Date Received	10/01/97	By: tat	(Initial)	PERMIT NUMBER	ACT/015/019
Title of Proposal:	Cottonwood Fan Portal			PERMIT CHANGE #	97C-1
Description:				PERMITTEE	PACIFICORP
# Copies Required	7	# Copies Received	1	MINE NAME	COTTONWOOD/WILBERG

Re: Approval of Fan Portal Reclamation Plan, PacifiCorp, Cottonwood/Wilberg Mine,
ACT/015/019-97C, Folder #3, Emery County, Utah

Re: Response to Deficiencies in Fan Portal Reclamation Plan, (Round 3), PacifiCorp, Cottonwood/Wilberg Mine, ACT/015/019-97C, Folder #8, Emery County, Utah.

SOUTH SEDIMENT BASIN - QUANTITY TABLE - FILL VOLUME

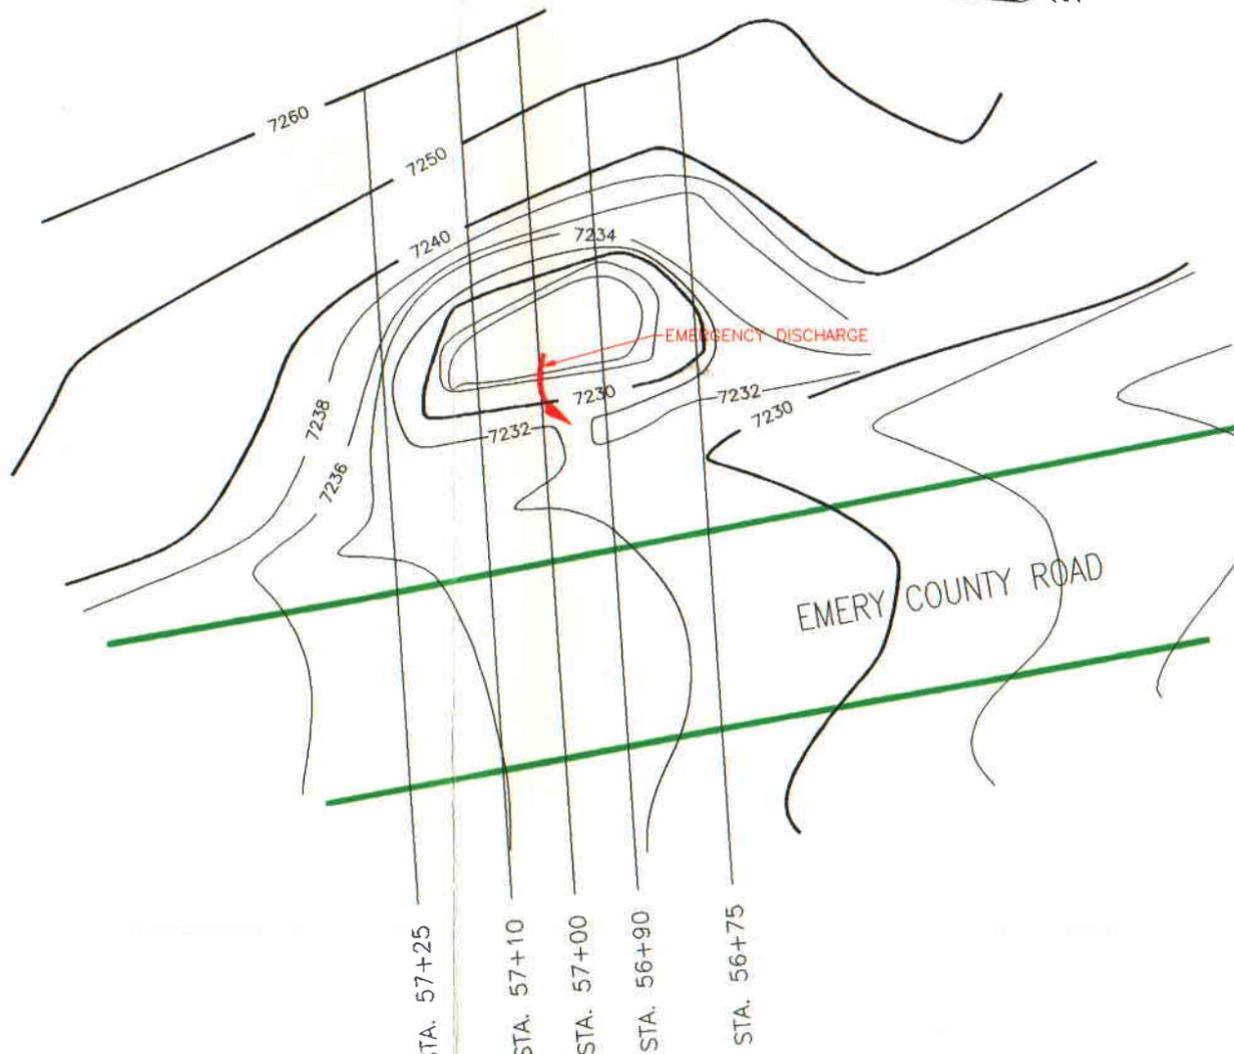
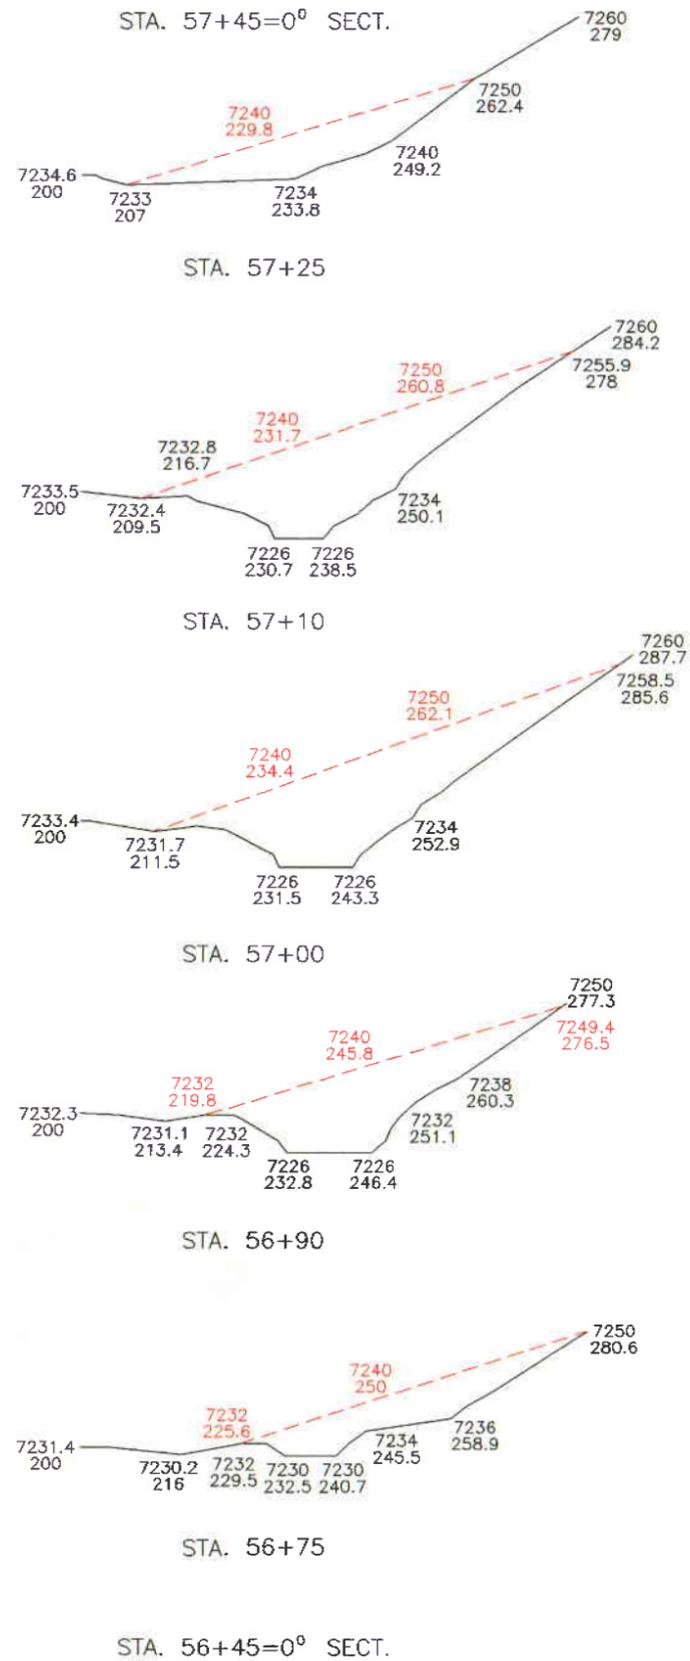
Please review the revisions to drawing KS1715D, Plate 5-4, of Volume 11 which have been made to reflect those contour and x-sections changes required for the pond areas, attached for your review.
